The Citation Twelve/Citation Twelve Deluxe

Professional 120 Watt Stereophonic Basic Power Amplifier

Technical Manual

ADDENDUM TO CITATION TWELVE TECHNICAL MANUAL

REVISED SECTION

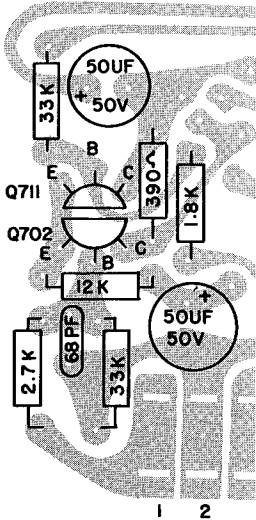
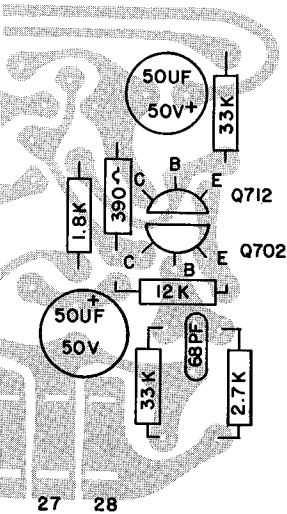
NOTE: ALSO SEE REVISED SECTION ON
P.C. BOARD (PAGE 4 & 5)

REVISED SCHEMATIC SECTIONS

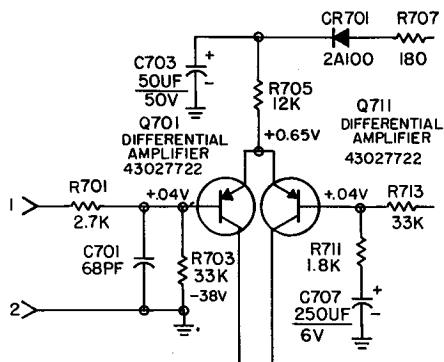
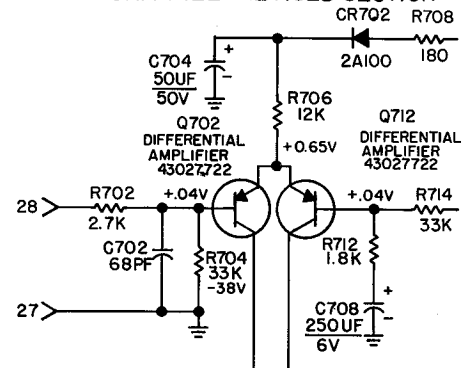
CIRCUIT REF.	DESCRIPTION	HK PART NO.	DESCRIPTION	HK PART NO.
DIODES				
CR7, CR8	Rectifier, Full Wave Bridge	41027230	FUSES AND CIRCUIT BREAKER	
			Fuse, Line 3A-3AG	45013291
TRANSISTORS				
Q701, Q702	Differential Amplifier	43027722	MISCELLANEOUS	
Q711, Q712	Differential Amplifier	43027722	Fuse Holder w/Hardware	65427001
			Line Cord	53026355
			Rubber Foot	62011692
RESISTORS				
R705, R706	Carbon Comp. 12K $\pm 10\%$ $\frac{1}{2}$ W	33311231 <i>70L</i>

RIGHT CHANNEL REVISED SECTION

LEFT CHANNEL REVISED SECTION

Q NUMBER	H.K. PART NUMBER	COMMERCIAL EQUIVALENT
701, 702	43027722	2N5807 <i>5087</i>
703, 704	43024306	RCA 40408
705, 706	43024219	RCA 40595
707, 708	43023221	2N5232
709, 710	43024218	RCA 40594
711, 712	43027722	2N5807
1,2,3,4	43024216	RCA 40636

2. The schematic on page 3 is modified as shown below.

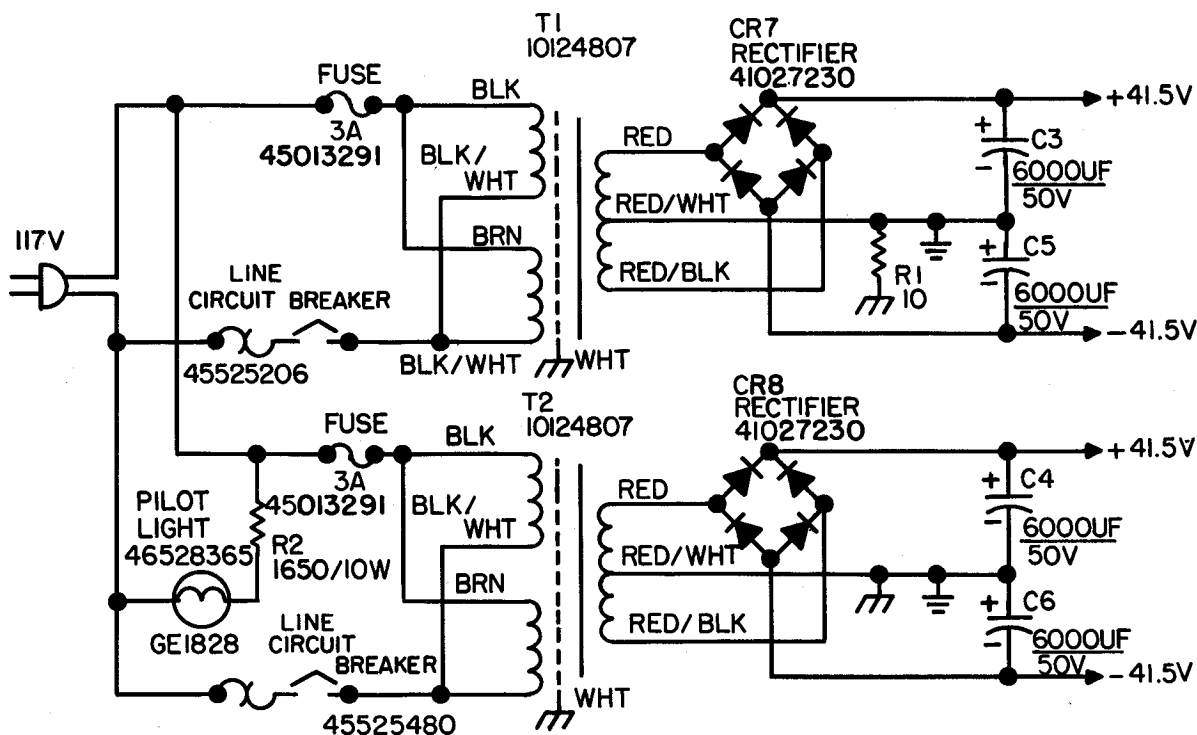
THE FOLLOWING MODIFICATIONS ARE TO BE MADE FOR THE CITATION TWELVE DELUXE ONLY.
